# Access Compliance Report

## Public Rights-of-Way

Intersection ID: 46033	Main Street: DOMINION_VILLAGE_DR	Cross Street: SUMMER_VALLEY_CT	Location: NE
ADA ID: ECDB942E98B3	Ramp Type: PerpDiag	Initial Pass/Fail: Fail	Overall Compliance: No
Severity Score: 10			
Codes/Mitigation Info/Possible Solution		Field Measurements/Component Compliance

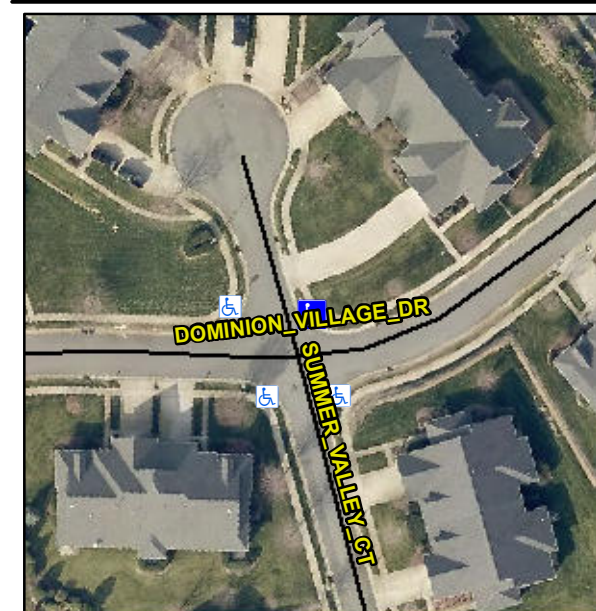
**Remove & Replace Curb Ramp With Two New Directional Ramps or Equivalent.**

**Not Found, R304.5.1, R304.5.3**

Compliance	Description	Data	Compliance	Description	Data
N/A	Ramp Length (in)	48.0	Yes	Ramp Slope (%)	5.4
No	Ramp Width (in)	41.0	No	Ramp XSlope (%)	2.1
N/A	Flare Type LT	N/A	N/A	Flare Type RT	N/A
N/A	Flare Slope LT (%)	N/A	N/A	Flare Slope RT (%)	N/A
N/A	Flare Traversable LT?	N/A	N/A	Flare Traversable RT?	N/A
N/A	Landing Length (in)	N/A	N/A	DWS Provided?	N/A
N/A	Landing Width (in)	N/A	N/A	DWS Contrast?	N/A
N/A	Landing Slope (%)	N/A	N/A	DWS Length (in)	N/A
N/A	Landing X Slope (%)	N/A	N/A	DWS Full Width?	N/A
N/A	Landing Curb? (Y/N)	N/A	N/A	DWS Offset (in)	N/A
N/A	Shared Landing?	N/A			
N/A	Gutter Ponding?	N/A	N/A	Gutter Slope (%)	N/A
N/A	Gutter Lip Ht (in)	N/A	N/A	Gutter X Slope (%)	N/A
N/A	Painted X Walk1?	No	N/A	Painted X Walk2?	No
	X Walk 1 Direction	To W		X Walk 2 Direction	To S
N/A	X Walk 1 Width (in)	N/A	N/A	X Walk 2 Width (in)	N/A
	X Walk 1 Slope (%)	1.5		X Walk 2 Slope (%)	3.2
	X Walk 1 X Slope (%)	2.1		X Walk 2 X Slope (%)	0.8
